Ms. Kimberly Shields, AICP
Planning/GIS Specialist
City of Grove City
4035 Broadway
Grove City, Ohio 43123
Subject: Mid-Ohio Food Bank New South Parking Lot
Control Number: 201506010035
Response Letter
EMHT #: 2015-0252

In response to the comments received from the City of Grove City on June 15, 2015, the plans have been modified as described herein.

GROVE CITY, FRANKLIN COUNTY, OHIO
DEVELOPMENT PLAN
FOR
MOFB
NEW SOUTH PARKING LOT
TITTLE SHEET

SHEET
C0.0

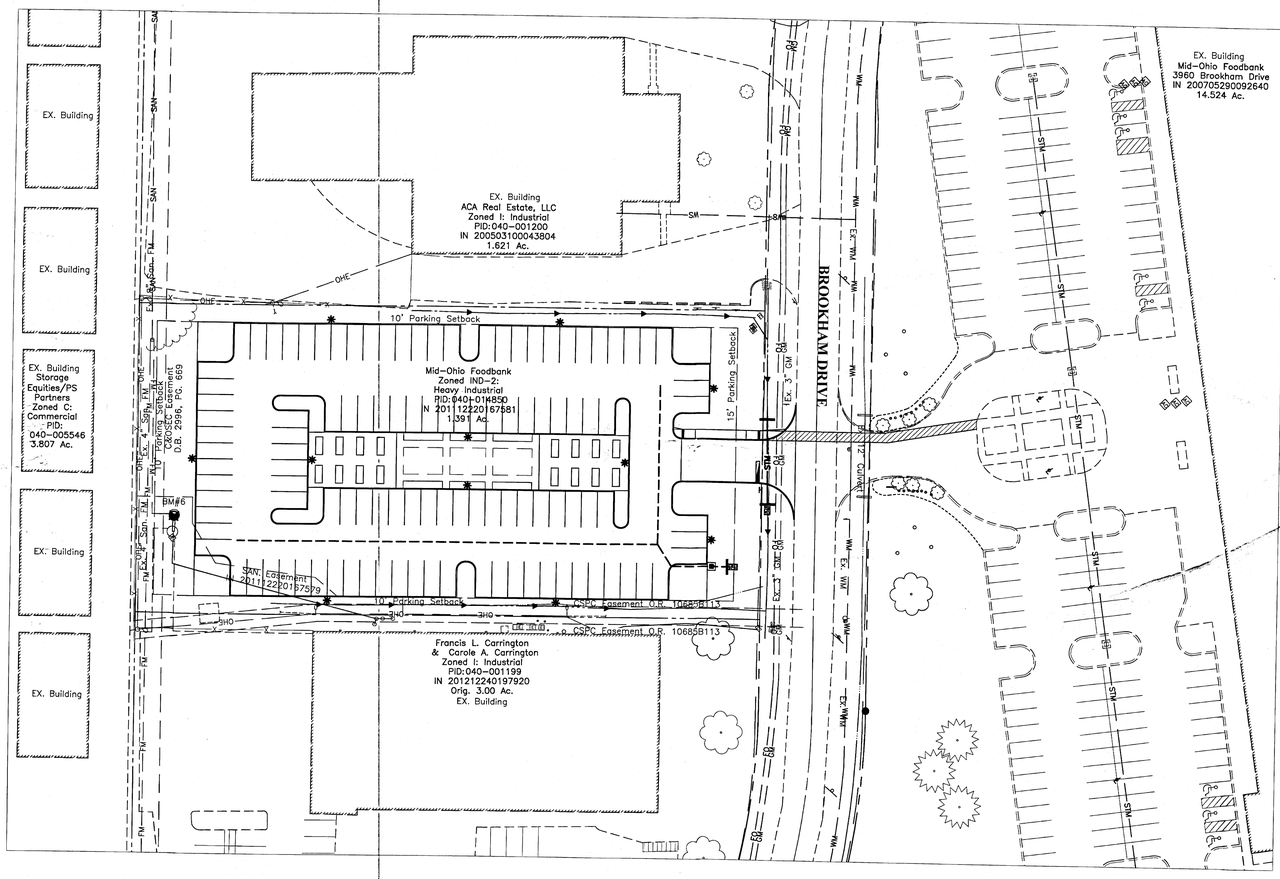
1. The parking setbacks listed on Sheet C0.0 should be updated as shown below and updated as plan sheets:
   - Front – 15'
   - Side – 10'
   - Rear – 10'

8. FEMA Note "A" Sheet C0.0 references a Flood Insurance Rate Map with effective date August 2, 1995. Most recent map is 39049C0318K with effective date 6/17/2008. Note should be revised as necessary.

9. Recorded instrument numbers should be shown where existing easements are specified to ensure that they have been recorded.

Response: The parking setbacks have been updated as requested.

Response: The FEMA note has been revised.

Response: Record information has been added to existing easements as requested.

SHEET
C1.0

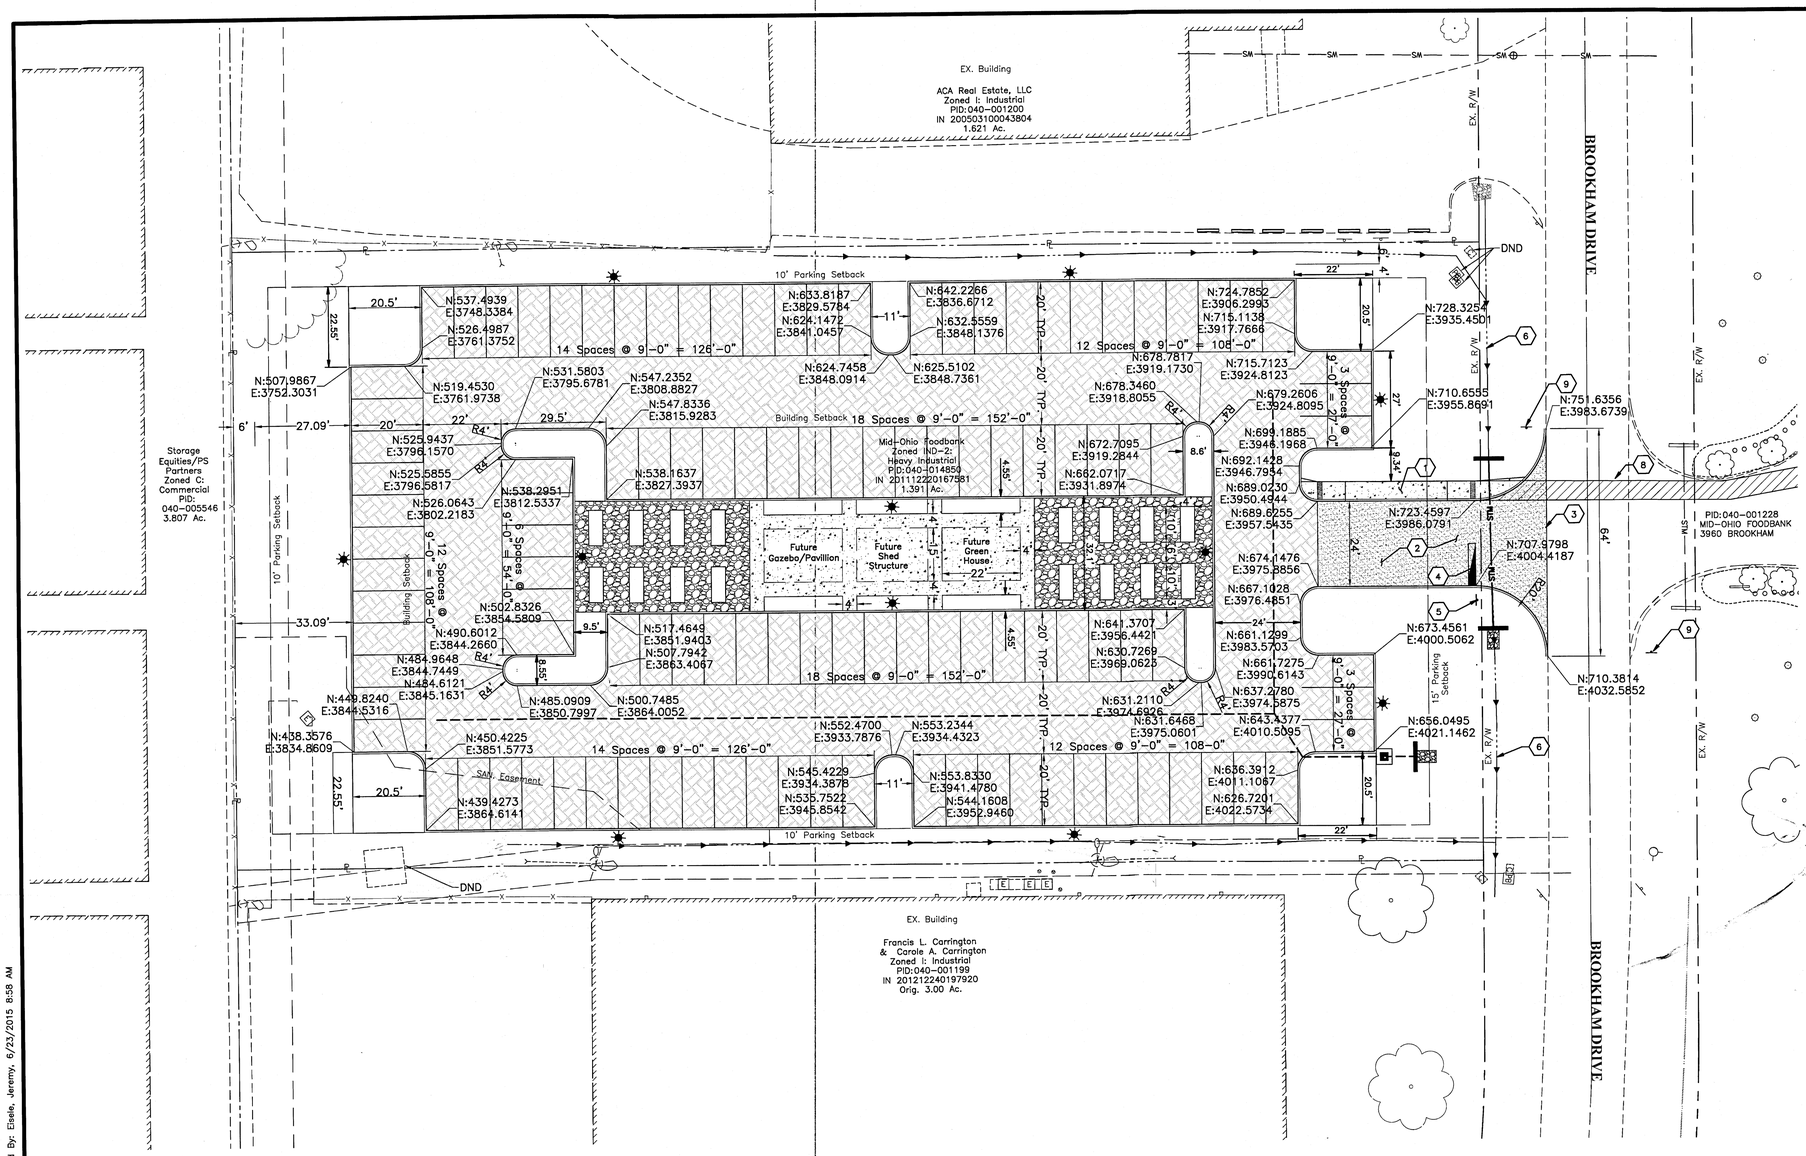
6. Pedestrian connectivity needs to be provided from the new parking lot to the existing building. Solar powered flashing pedestrian crossing signs shall be installed in the ROW to caution drivers of the crossing.

11. Centerline entrance to site from Brookham Drive should line up with existing centerline entrance to the north.

Response: A pedestrian crossing with solar powered signs has been added to the plans.

Response: The entrance drive location has been revised to line up with the existing entrance and to provide a better pedestrian crossing.

SHEET: C2.0

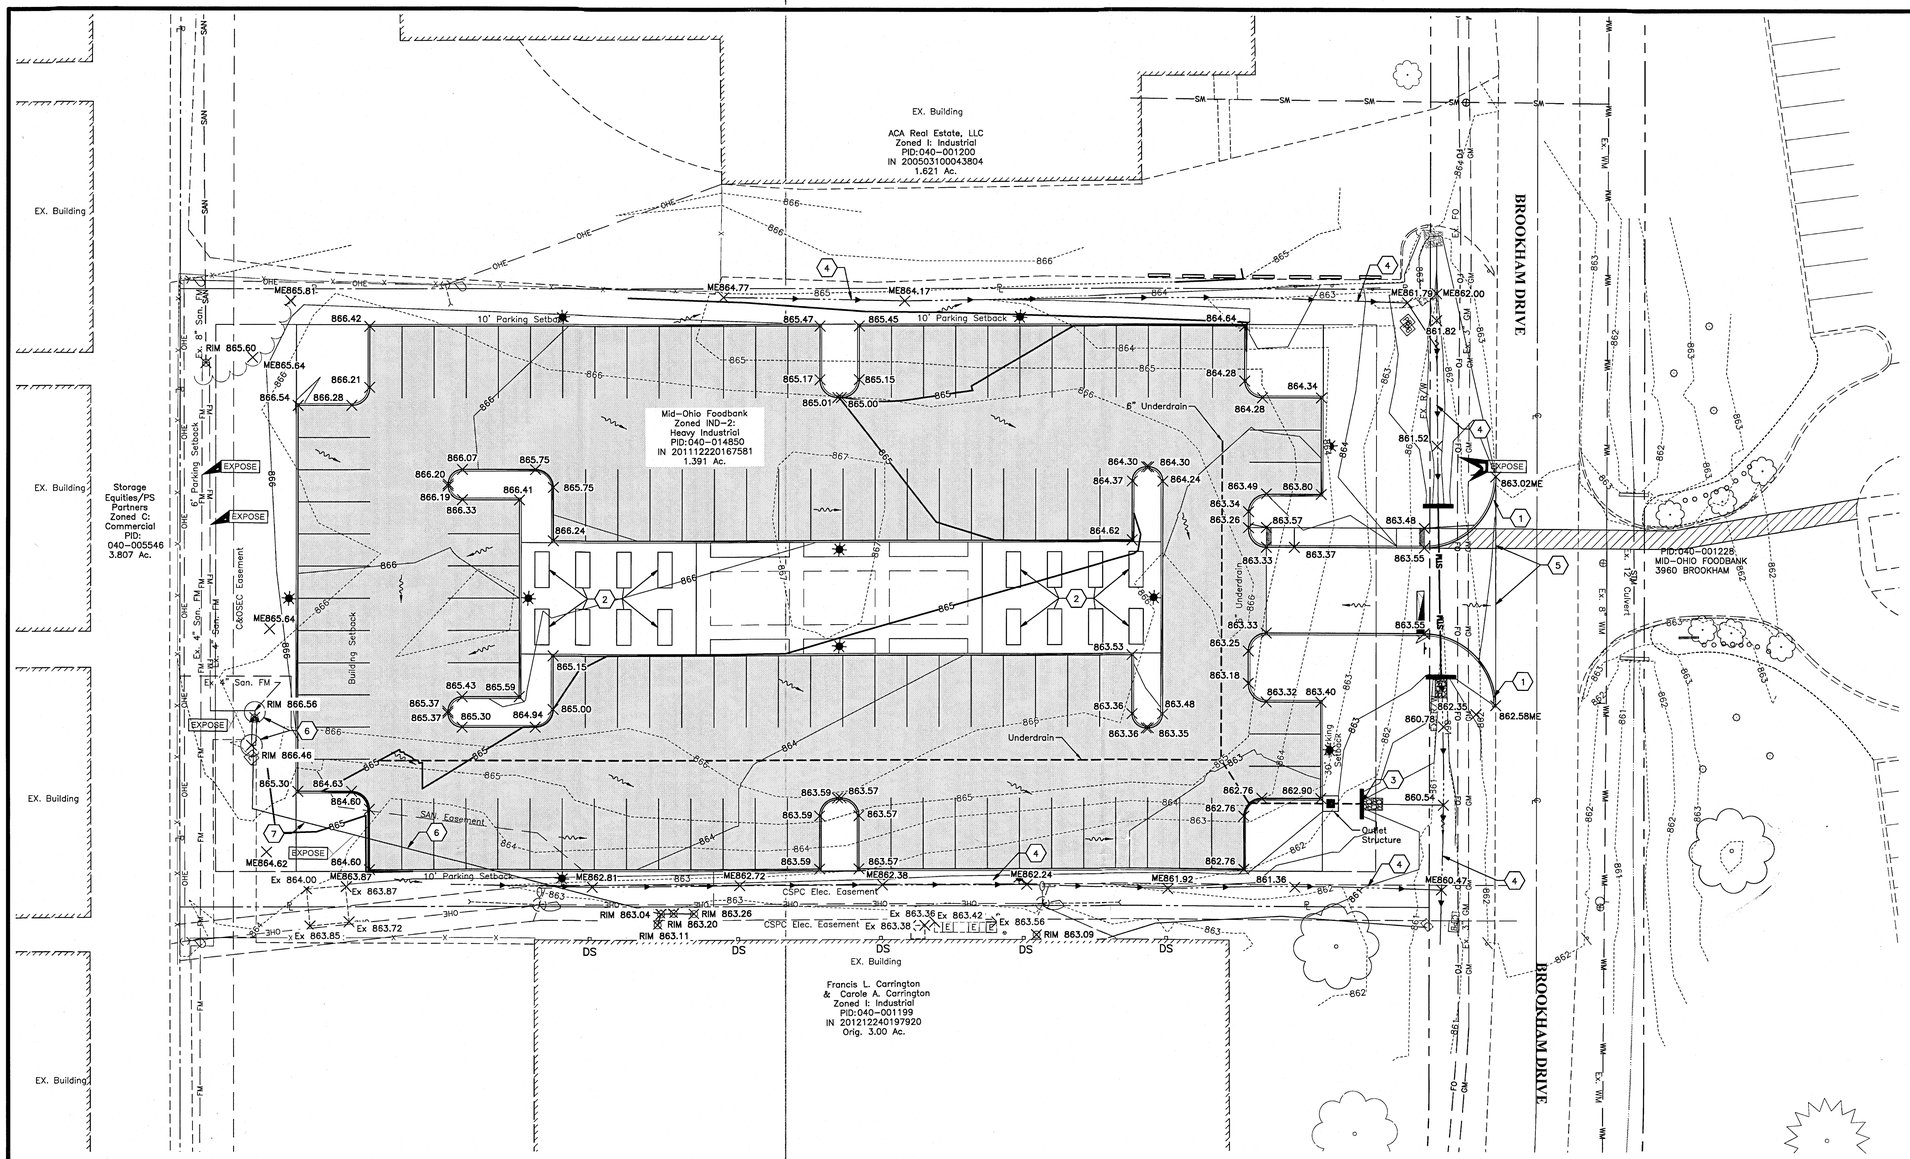
2. The landscape plan as indicated in the note on Sheet C0.0 will need to be submitted with revised plans. The landscape plan will need to show details for all proposed landscaping including perimeter parking lot landscaping, landscaping within parking peninsulas, and details on the raised garden beds (referred to on Sheet C2.0).

Response: The landscape plan has been included in this submission.

SHEET: C3.0

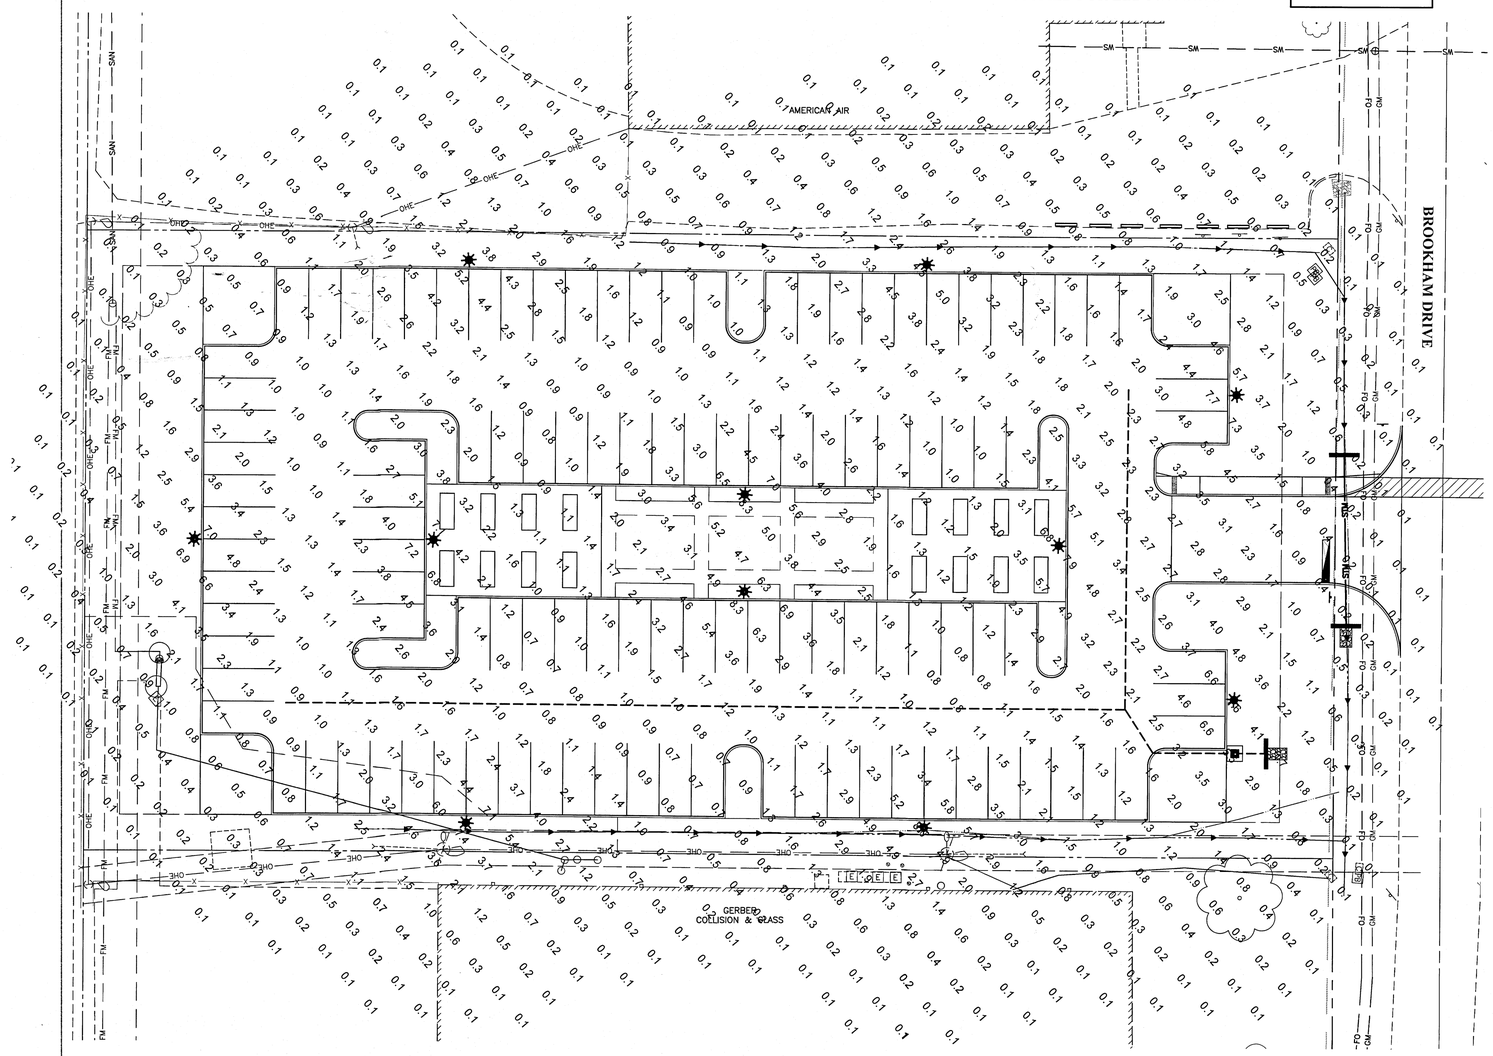
3. A photometric plan should be submitted showing that all portions of the parking lot meet the 0.5 footcandle minimum.

4. Details (cut sheets) should be submitted for proposed lighting fixtures. Fixtures should match those on the main Mid-Ohio Food Bank site.

Response: A photometric plan has been included in this submission.

Response: Lighting fixture details have been included on the photometric plan as requested.

SHEET TITLE
Landscape Plan

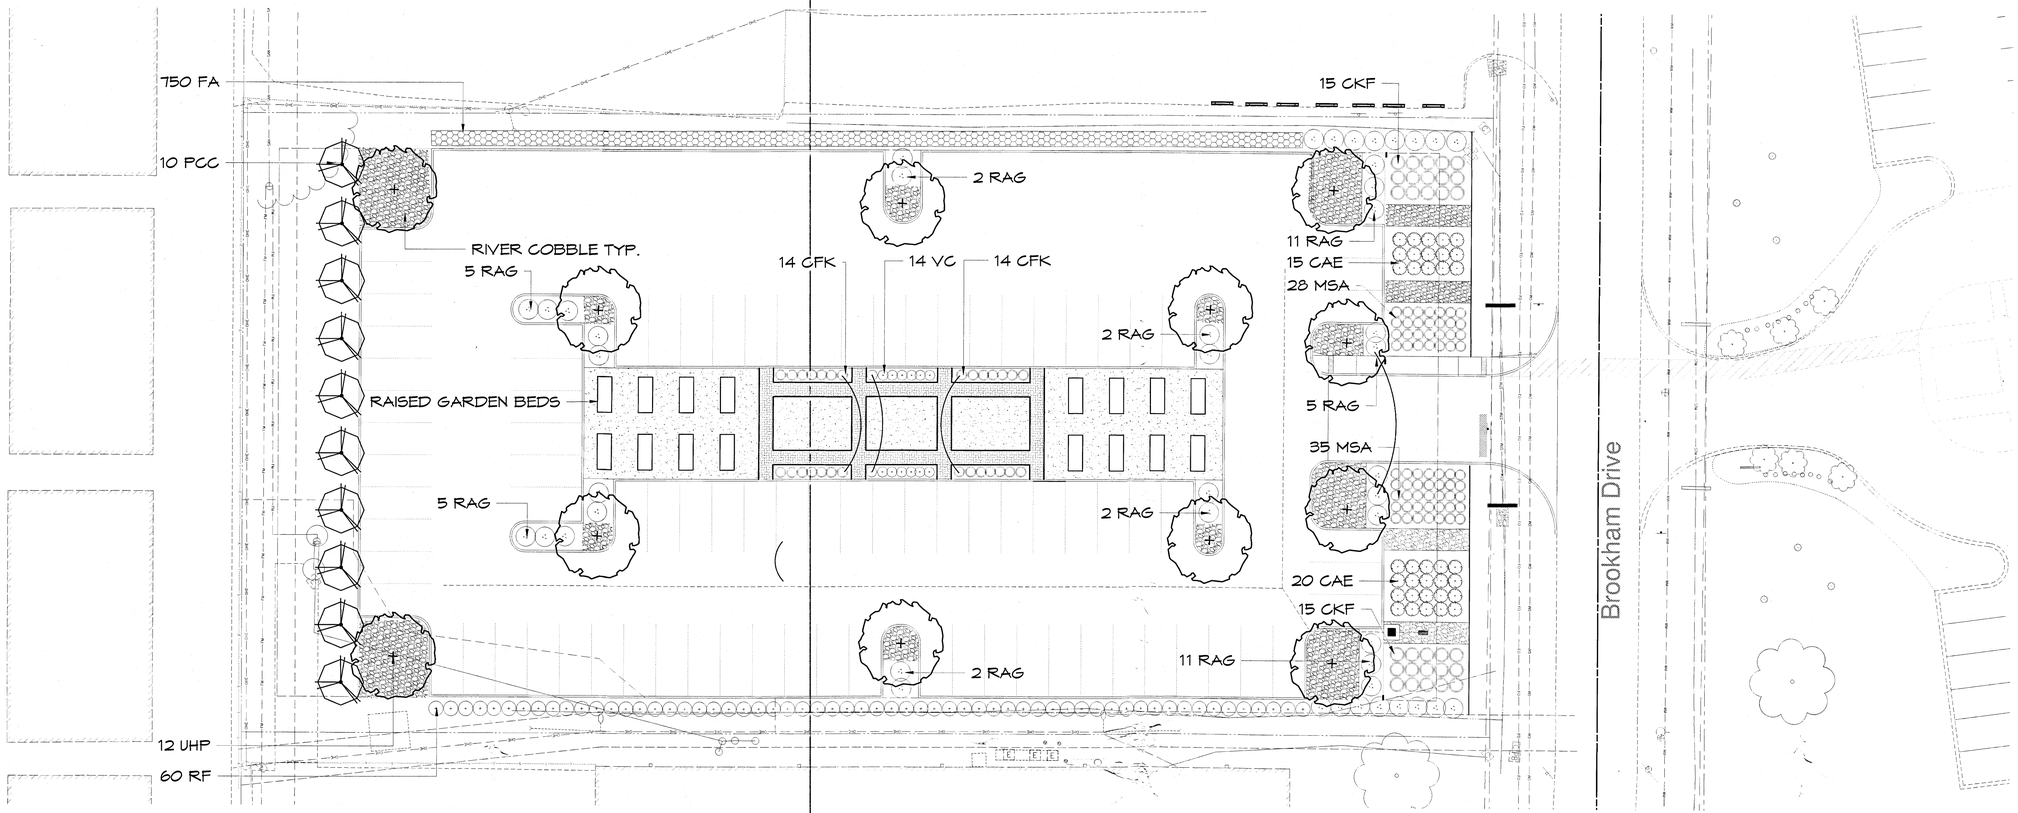
5. 1136.05(b): A landscape plan needs to be provided.

Response: A landscape plan has been provided in this submission.
